# Economic Evaluation of the Cadiz Groundwater Storage and Dry Year Supply Project, Metropolitan Water District of Southern California

July 16, 2001

The Pacific Institute for Studies in Development, Environment, and Security 654 13<sup>th</sup> Street, Preservation Park, Oakland, CA 94612 www.pacinst.org

Figure 1: Sensitivity to Quantity of Native Groundwater Transferred

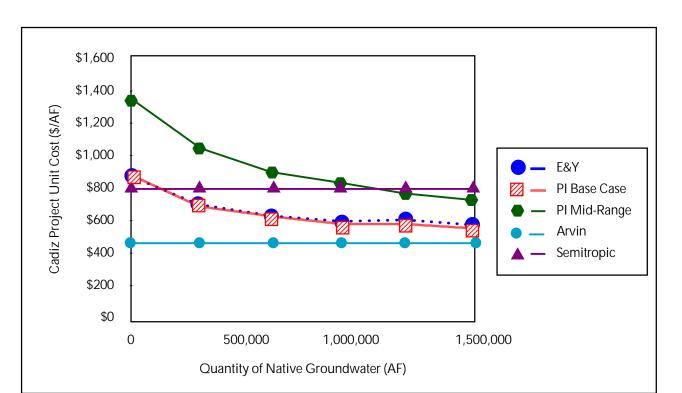
Table 1 and Figure 1 compare three estimates of the cost of water from the Cadiz project at six levels of native groundwater take varying from 0 acre-feet to 1,500,000 acre-feet. The Ernst & Young (January 2001) and Pacific Institute (PI) Base Case estimates are very similar, and give the impression the Cadiz project is competitive with the Arvin and Semitropic projects. The much more realistic Pacific Institute mid range estimate, however, shows in sharp contrast that the Cadiz project does not compare well with the Arvin or Semitropic projects unless a significant amount of native groundwater can be taken. For example, at 900,000 acre-feet of native groundwater transfer the Cadiz project (\$840) is estimated to cost more than the Semitropic project (\$797) and is much more expensive than the Arvin project (\$491).

At 300,000 acre-feet of native groundwater, we estimate that water from the Cadiz project will cost more than \$1,050 per acre-foot, *excluding* future water treatment costs and environmental mitigation costs. At 0 acre-feet of native groundwater — a direct storage-only comparison with the Arvin and Semitropic projects — we estimate that water from the Cadiz project will cost more than \$1350 per acre-foot. Although Cadiz must turn over the
